Work Order ID 69686

Item Name: Crosstube Turning Detail

DART AEROSPACE LTD	Work Order:	65684
Description: Crosstube Assembly (205/212/412 High Fwd)	Part Number:	D212-664-141
Inspection Dwg: D212-664-141 Rev: D		Page 1 of 1

DRAWING NO. D212-664-141	TITLE XTUBE ASSY (205/212/412 HI FWD)	REV. D	DART AEROSPACE LTD ENGINEERING ORDER		D.E.O. NO. D212-664-141-D-1	SHEET NO. SHEET 1 OF 2	SCALE NTS
DRAWN	CHECKED <i>JP</i>	MFG. APPR. <i>BE</i>	APPROVED <i>MP</i>	DE APPR. <i>MP</i>			
DATE 11.04.07	DATE 11.07.11	DATE 11.04.12	DATE 11/04/12	DATE 11.04.12

**D212-664-141/-141B
ASSEMBLY DETAIL**

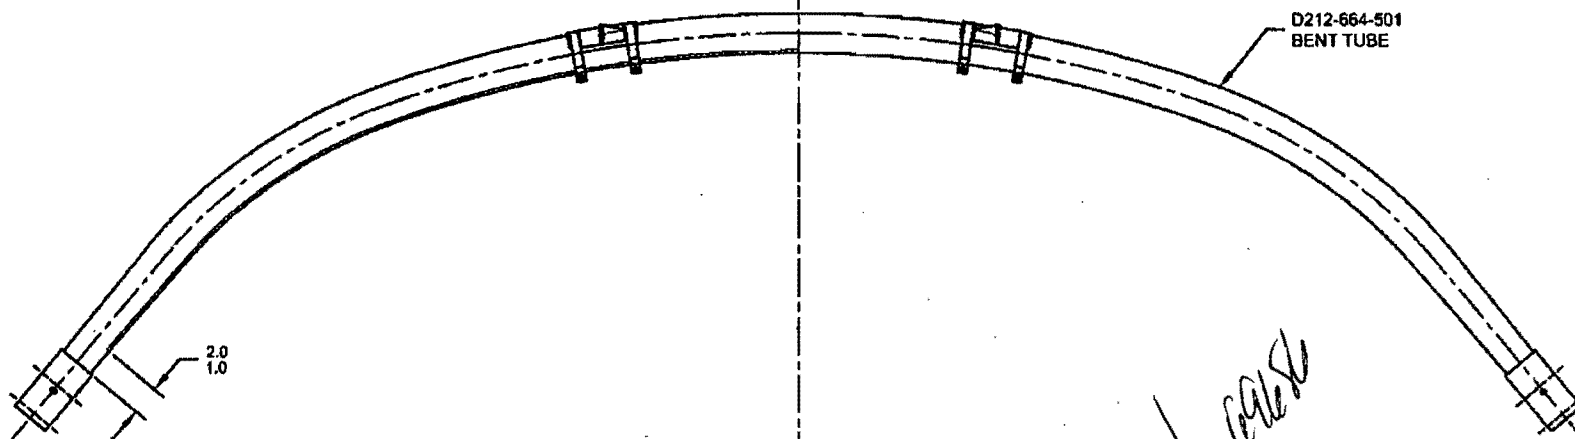
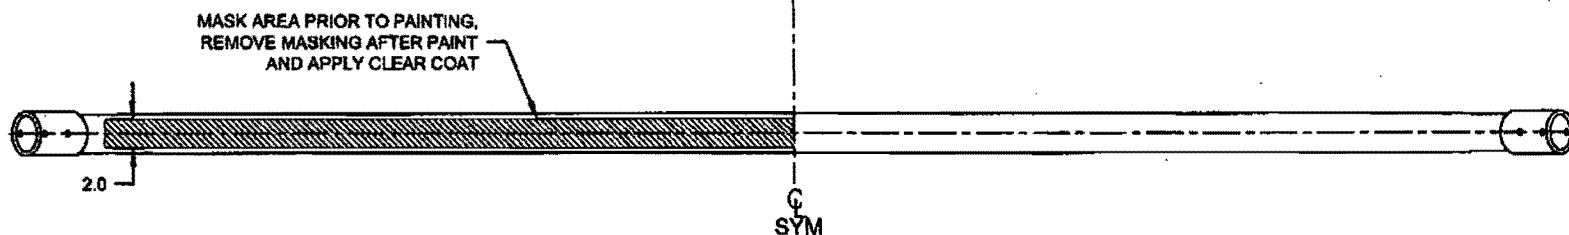
PURPOSE:

ADD AN INSPECTION WINDOW TO UNDERSIDE OF CROSSTUBE.

NOTES 2 OF SHEET 1 IS AMENDED AS FOLLOWS:

- 2) FINISH: CHEMICAL CONVERSION COAT PER DART QSI 005 4.1
PRIME INSIDE AND OUTSIDE PER DART QSI 005 4.2
MASK UNDERSIDE OF CROSSTUBE AS SHOWN (HATCHED AREA) AND
PAINT OUTSIDE PER DART QSI 005 4.2
REMOVE MASKING AND APPLY CLEAR COAT

- 2) FINISH: CHEMICAL CONVERSION COAT PER DART QSI 005 4.1
PRIME INSIDE AND OUTSIDE PER DART QSI 005 4.2
PAINT OUTSIDE PER DART QSI 005 4.2
